REMARKS

This supplemental amendment and response supplements the amendment and response filed September 28, 2004, as discussed during an October 7, 2004 personal interview.

Attachments: Replacement and annotated sheets for Figure 4

Fig. 4

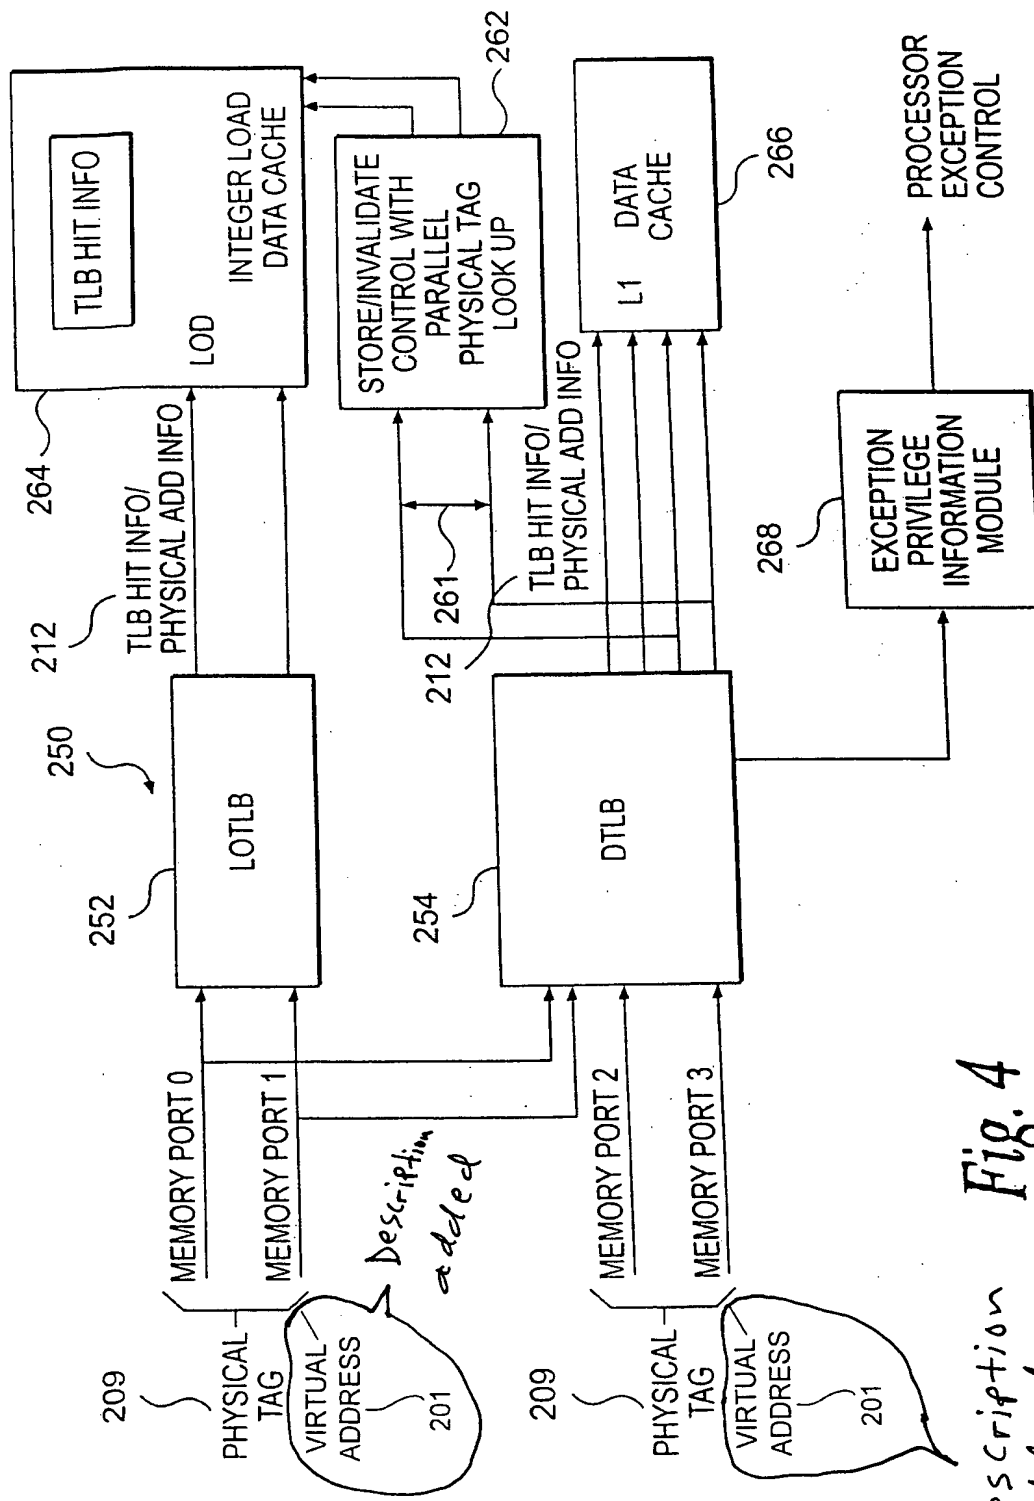
On page 2 the Office Action objects to the drawings. In particular, the Office Action objects to the drawings because, allegedly, the steps of receiving first and second virtual address information recited in claim 1 are not shown in the figures. Figure 4 is amended to overcome the objection, and withdrawal of the rejection is respectfully requested.

The attached sheet of drawings includes changes to Figure 4. This sheet, which includes Figure 4, replaces the original sheet including Figure 4. Figure 4 has been amended by adding the description, "VIRTUAL ADDRESS" to memory ports 1 and 3.

Description added

Description added

Description added
